Service Bulletin
Hi Fi Products

Model: **D-330**

No. **509**

Subject: **No operation and/ or Sound Skipping**

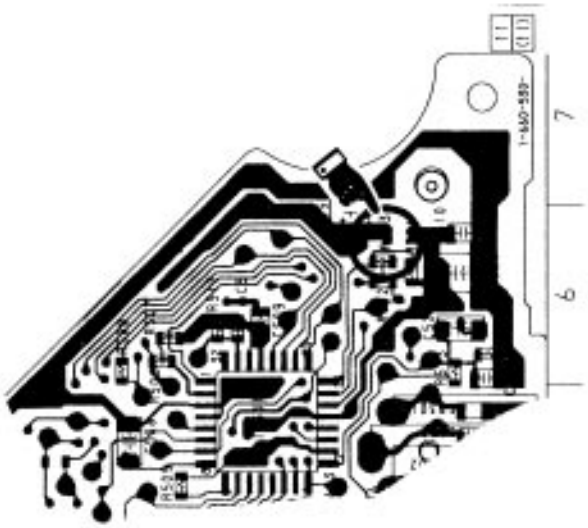
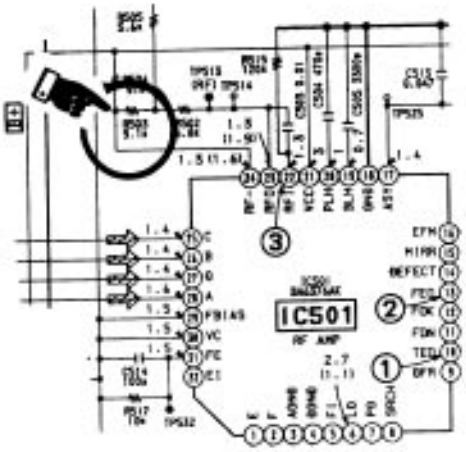
(212) No operation and/ or Sound Skipping

REF	FORMER		NEW	
	DESCRIPTION	PART NUMBER	DESCRIPTION	PART NUMBER
R503	12 KOHM CHIP RESISTOR	1-216-834-11	9.1 KOHM RESISTOR	1-218-345-11
